Service Bulletin

Affected Model(s): 2002 ZL 600 EFI SS (Early Build)

Bulletin No: 2002-1-01

Subject: Rear Shock Link Mounting Location

Fig. 1

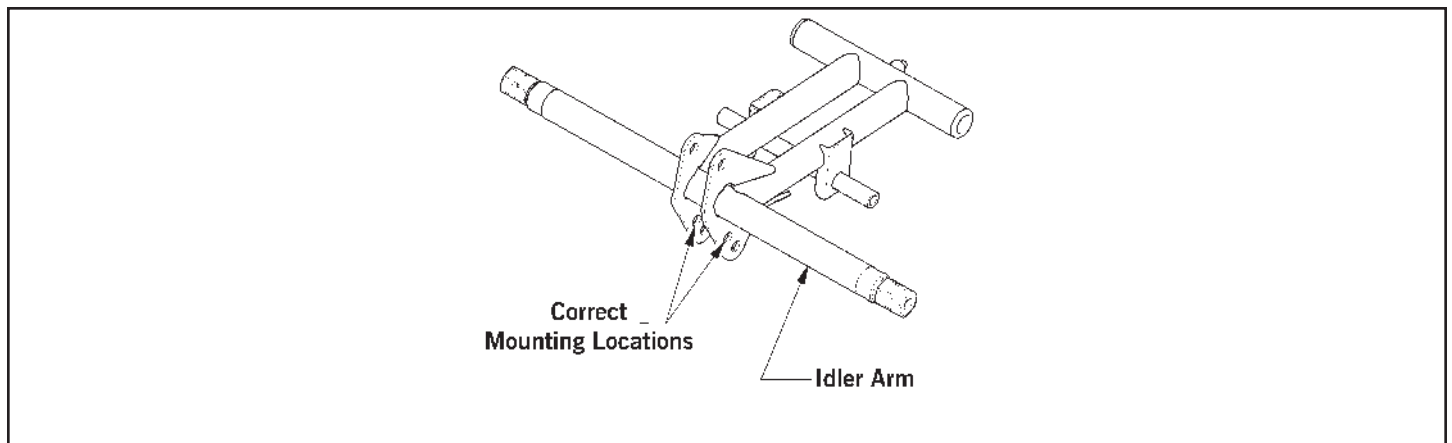
Condition: In some cases, the idler arm shock mounting bracket may come into contact with the shock reservoir when the skid frame is collapsed or “bottomed” out. This condition may cause damage to the shock reservoir clamp, the top edge of the shock reservoir, or the reservoir hose.

It has been determined through extensive testing that the above condition will occur if the upper shock link eyelets are mounted in the incorrect mounting holes (lower) on the idler arm bracket. Although Arctic Cat is confident that the majority of the shock links were installed properly, it has come to our attention that, in some cases, the shock links may have been installed in the lower mounting holes during assembly.

Solution: Inspect the mounting location of the rear shock links on the affected snowmobile. If the shock links are mounted in the lower holes in the rear idler arm bracket, it will be necessary to move the mounting locations to the upper mounting holes. See Fig. 1 for the proper mounting location.

■ **NOTE:** The shock links (p/n 0704-350) should be mounted in the upper mounting holes of the bracket. If the shock links are mounted in the upper mounting holes, the bracket will not come into contact with the reservoir.

5. Making sure the flanged axle links, shock sleeves, and the shock link spacer are in the proper positions, align a shock link eyelet with the **upper** bracket mounting hole.

6. Making sure the shock link spacer is positioned between the shock link eyelet mounting holes, insert the cap screw w/washer through the shock link eyelets. Secure with washer and lock nut. Tighten to 3.2 kg-m (23 ft-lb).
